ADDENDUM TWO

ADDENDUM NO. 2

PROJECT TITLE: Asbestos Abatement
Lakeview Center

ISSUANCE DATE: 12/6/12

SHEET 2 - PHASING

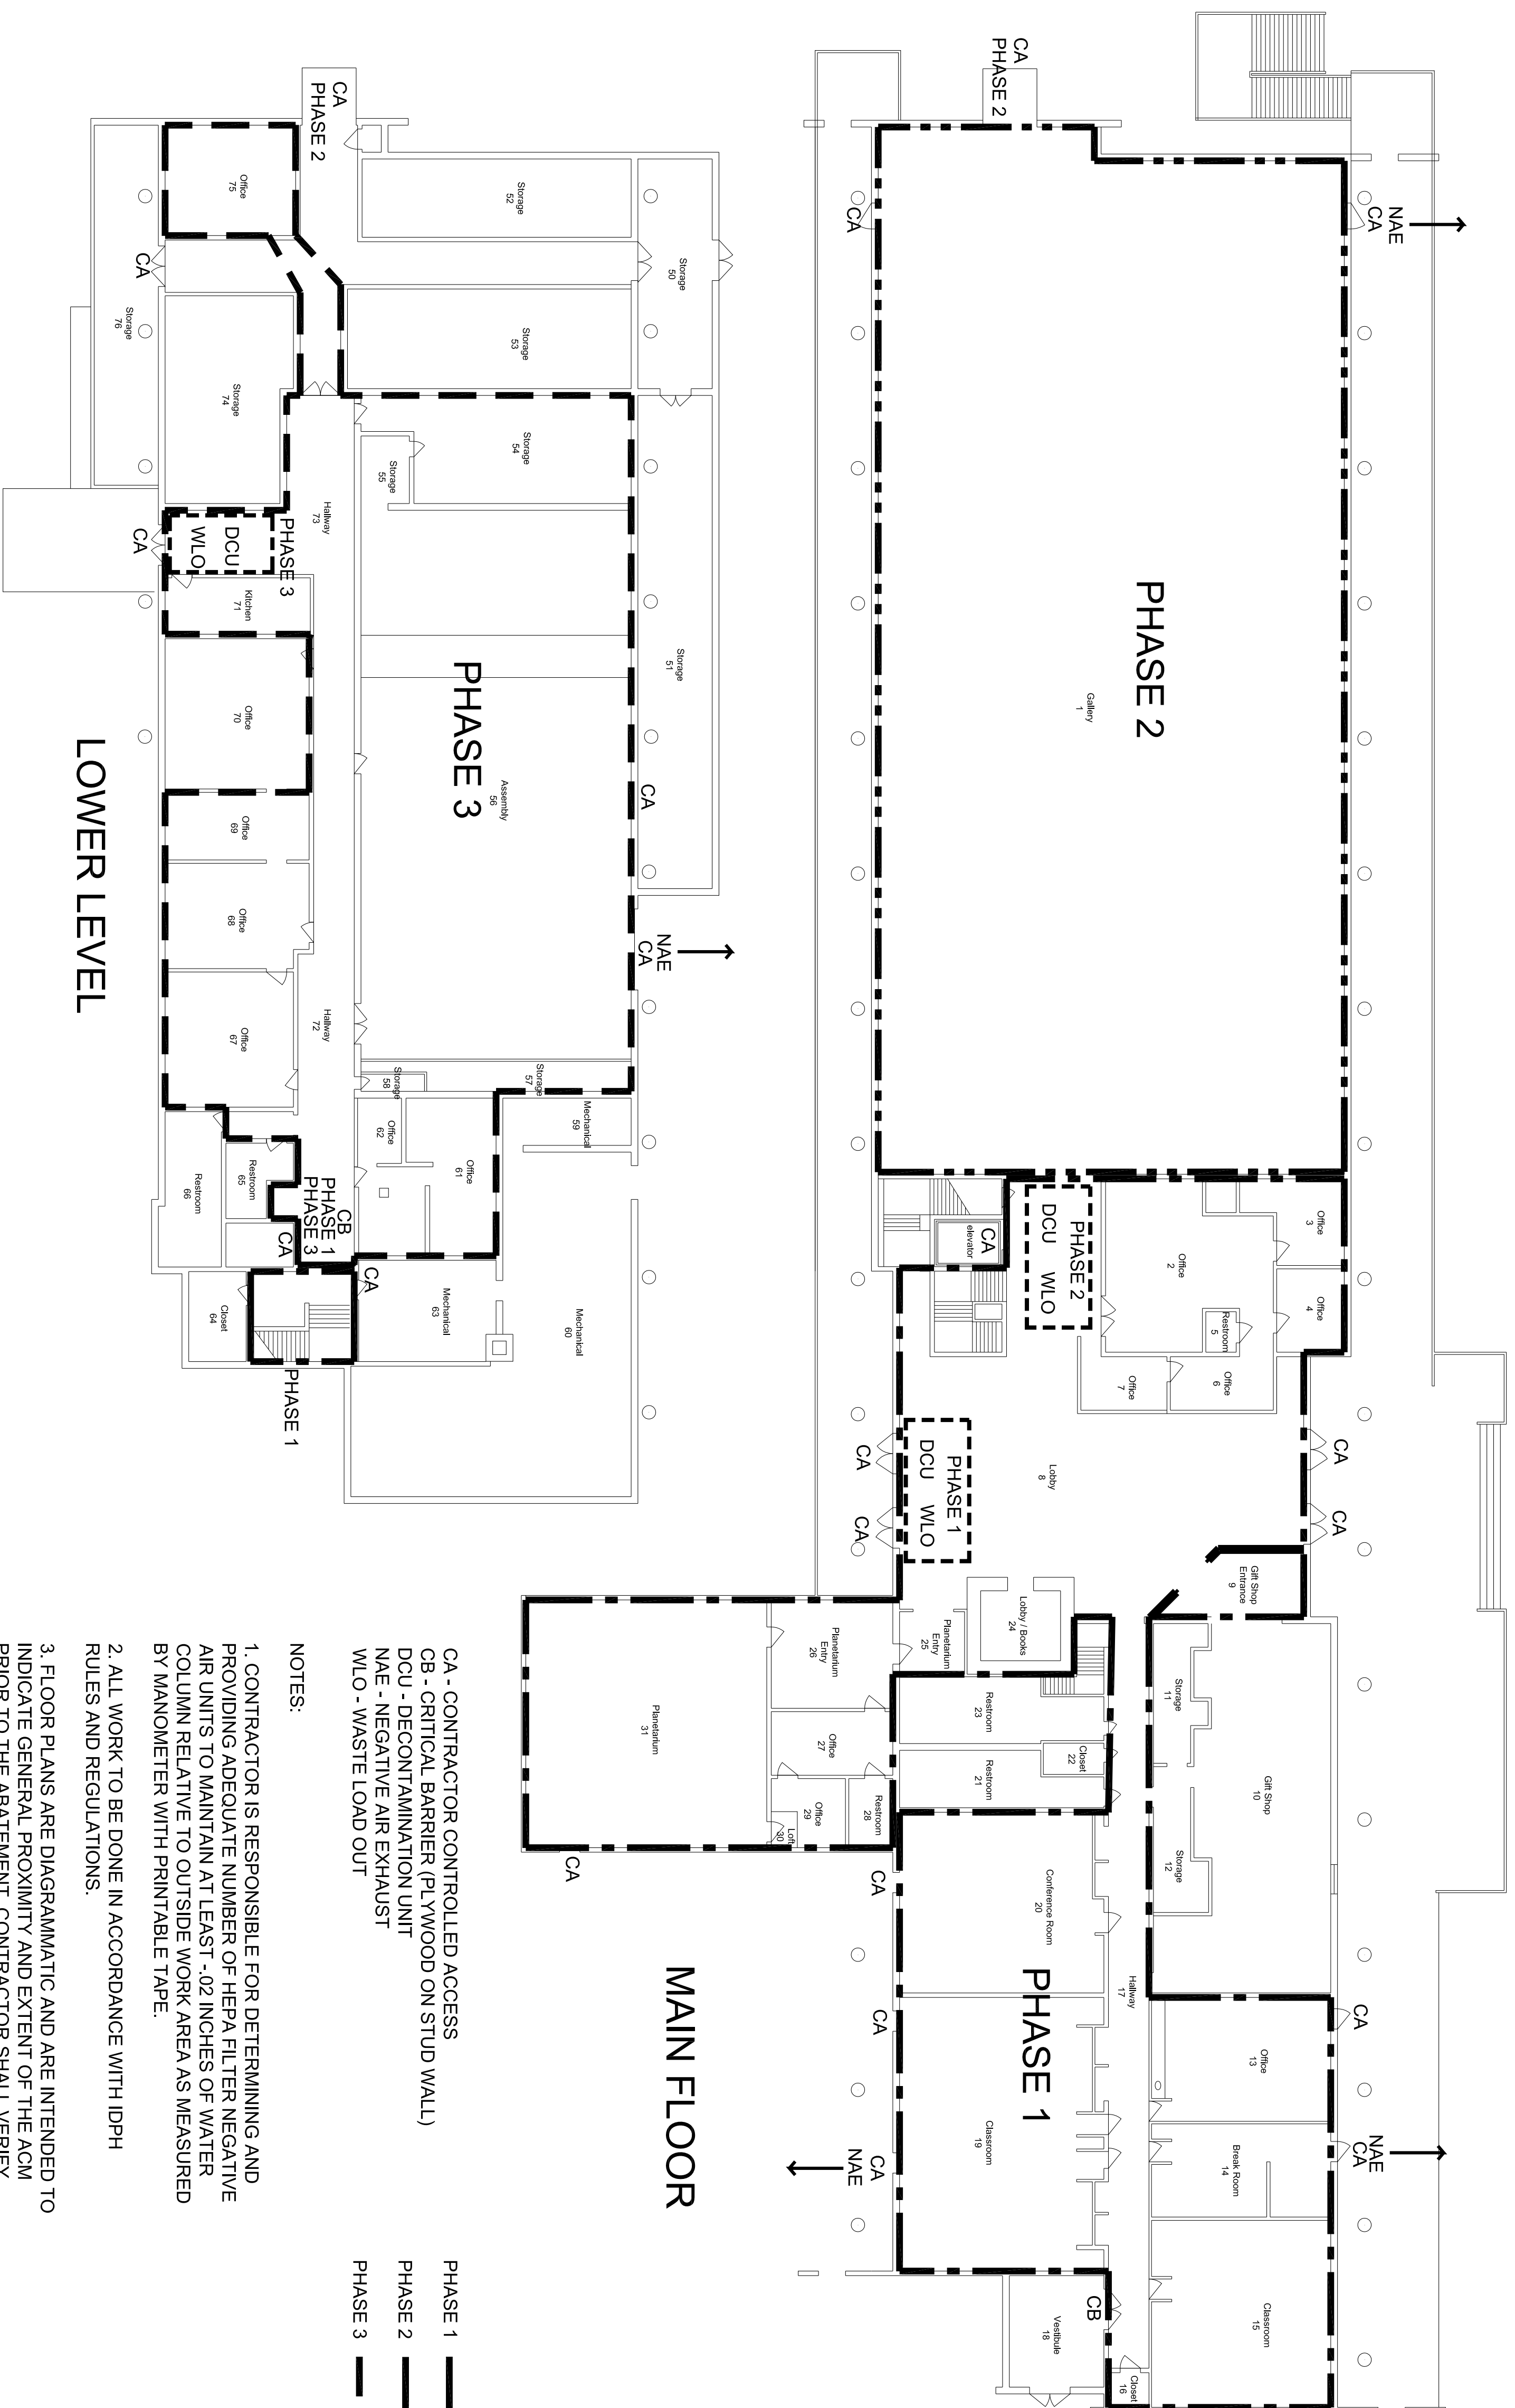
See attached 24"x36" Sheet 2 "Phasing" and Sheet 3 "General Scope".
